Response to

Request for Additional Information No. 378(4409, 4513, 4490), Revision 2, Supplement 7

U. S. EPR Standard Design Certification
AREVA NP Inc.
Docket No. 52-020
SRP Section: 06.02.01 - Containment Functional Design
SRP Section: 06.02.02 - Containment Heat Removal Systems
SRP Section: 06.02.03 - Secondary Containment Functional Design

Figure 06.02.01-87-13 — Temperatures of Nodes 21 and 22

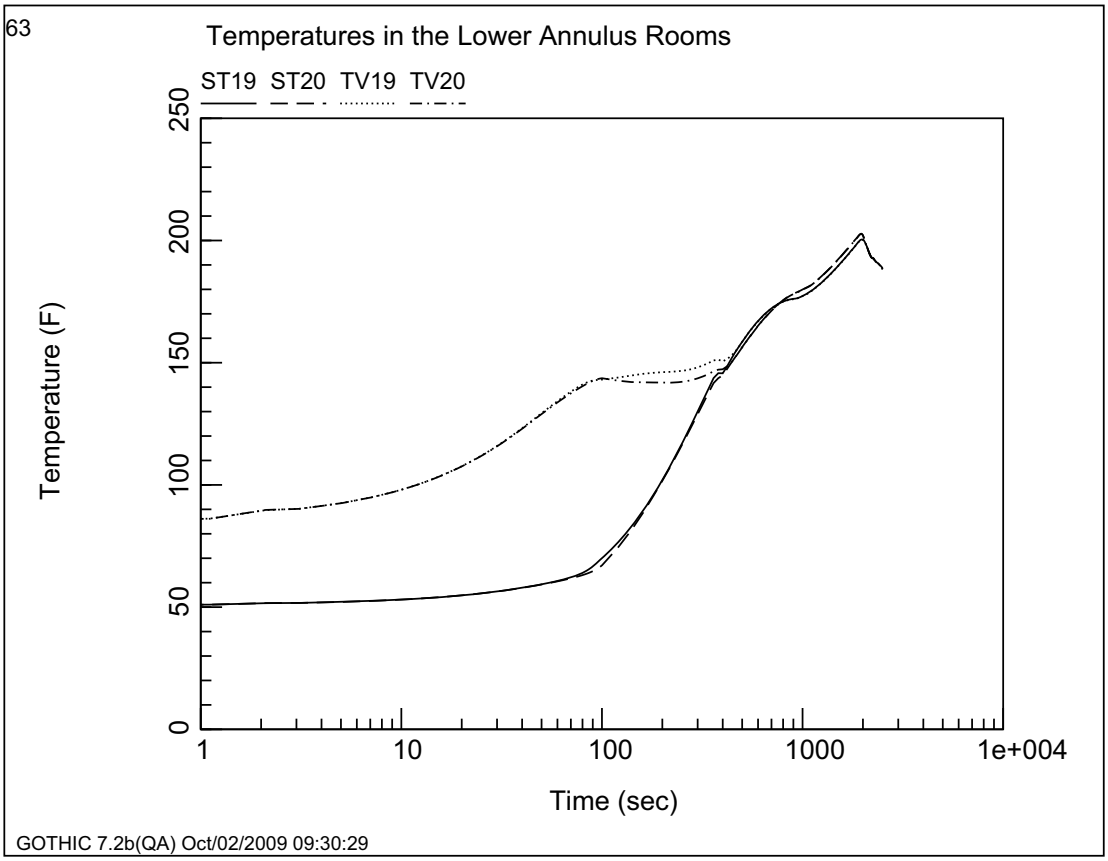
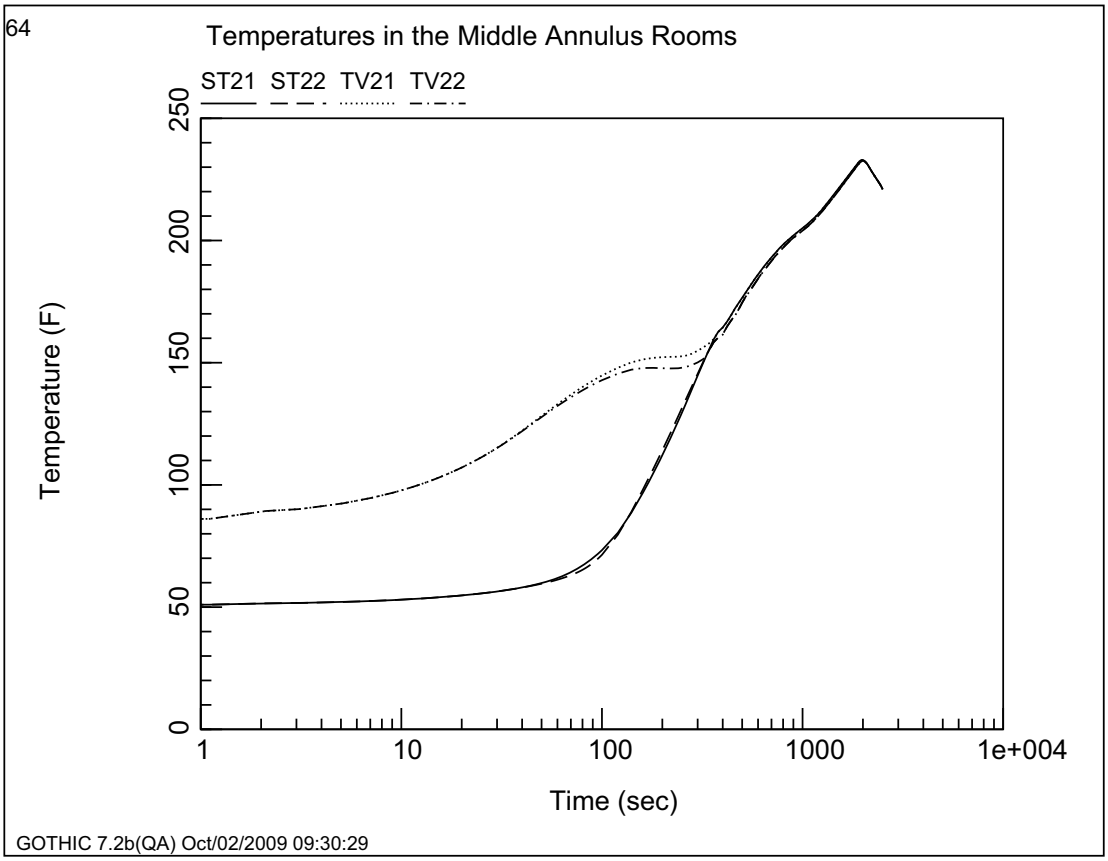
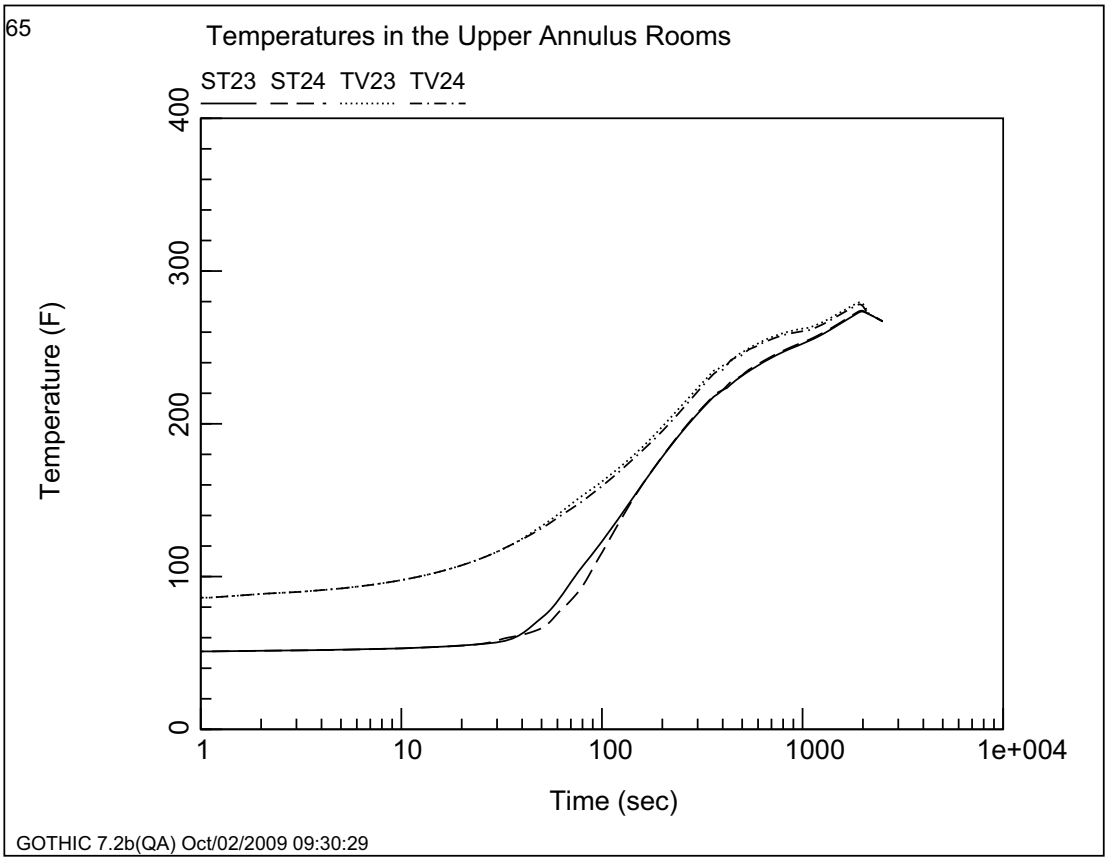
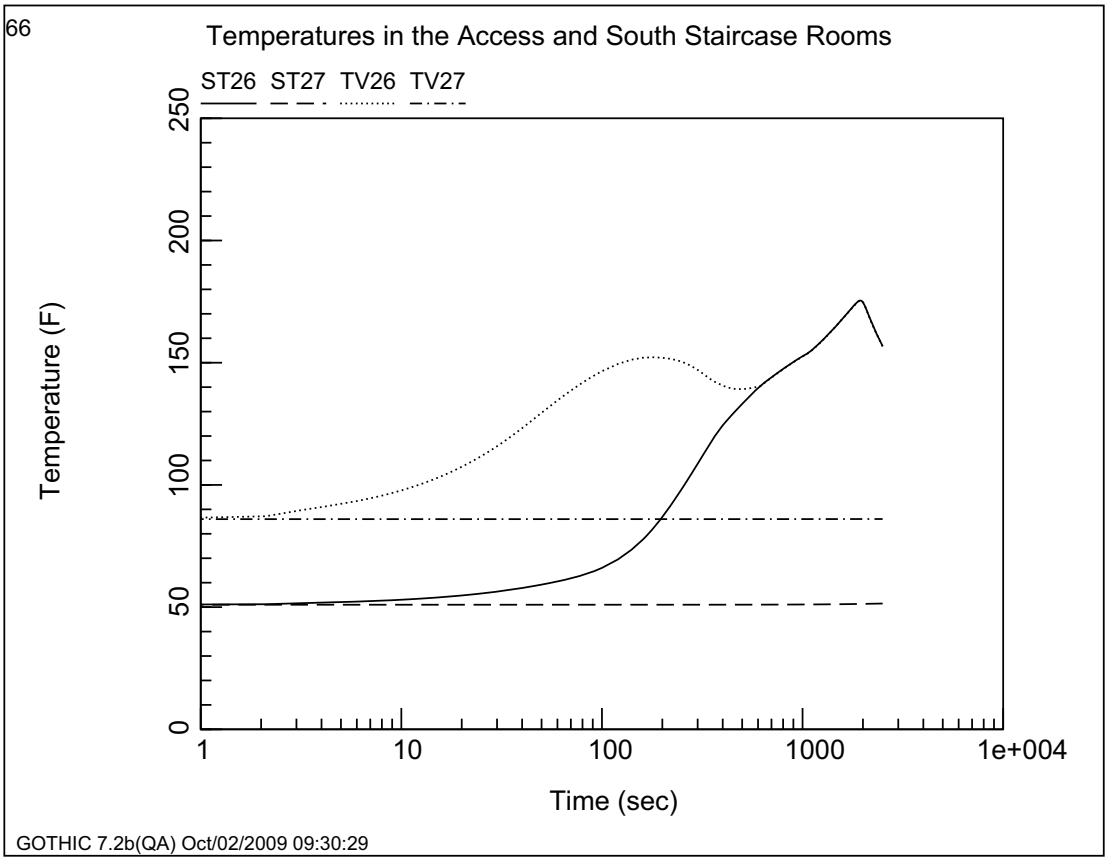
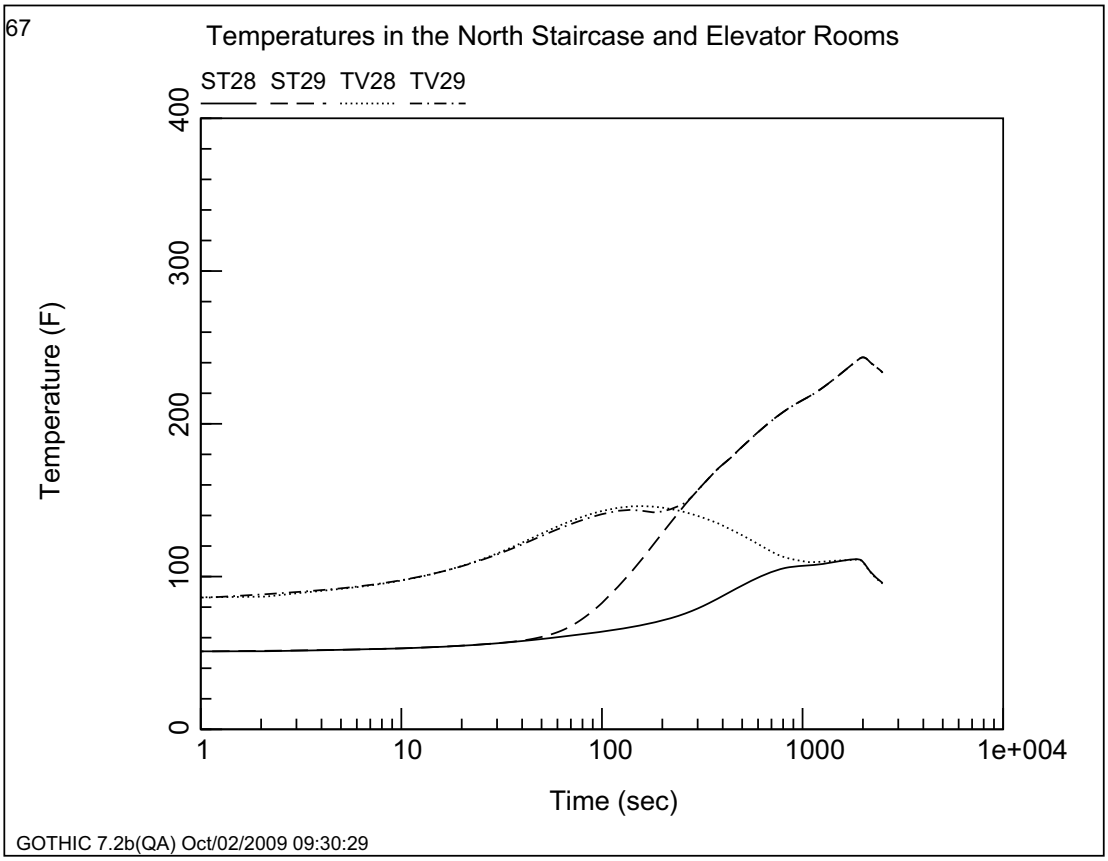
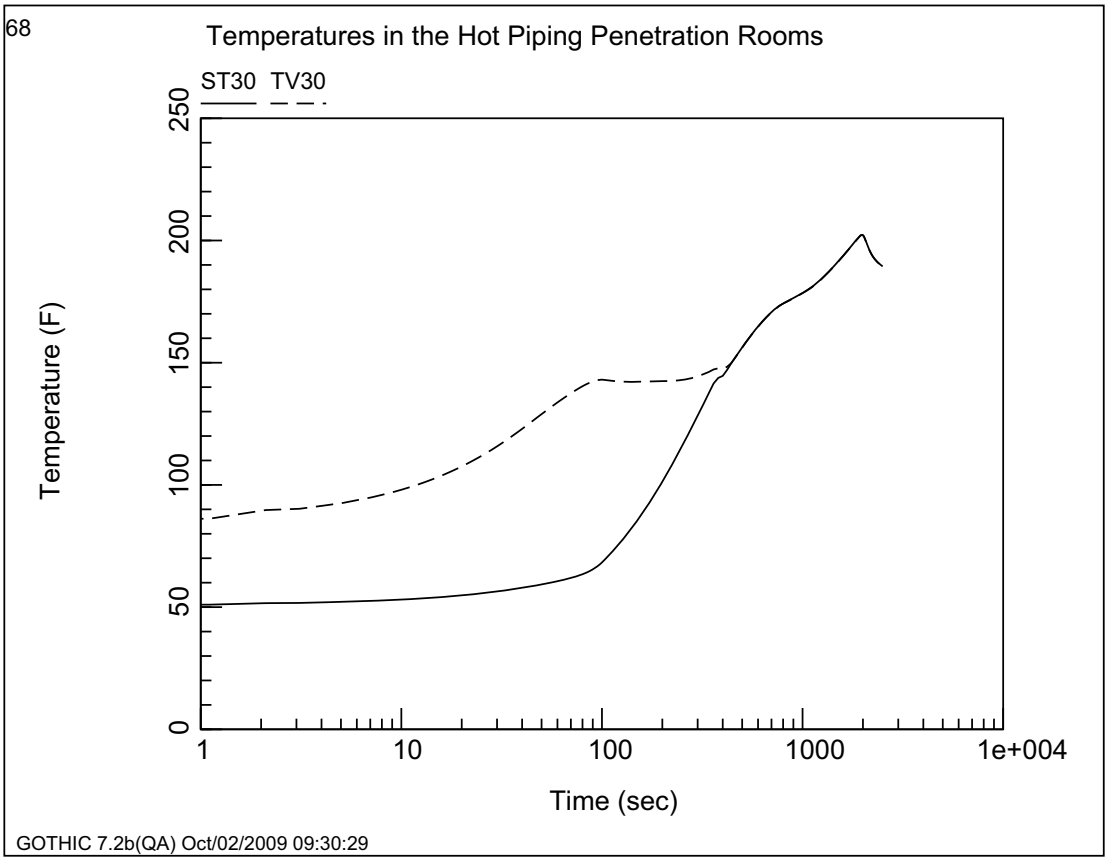
e) Time history atmospheric temperature plots for lumped parameter nodes below the dome (nodes 1-30, excluding node 25). The atmospheric temperature plots should include both gas (vapor) and saturation temperatures.

e) Figures 06.02.01-87-03 through 06.02.01-87-17 and Figure 06.02.01-87-01 show the time history atmospheric temperature plots for nodes 1 through 30, excluding Node 25.
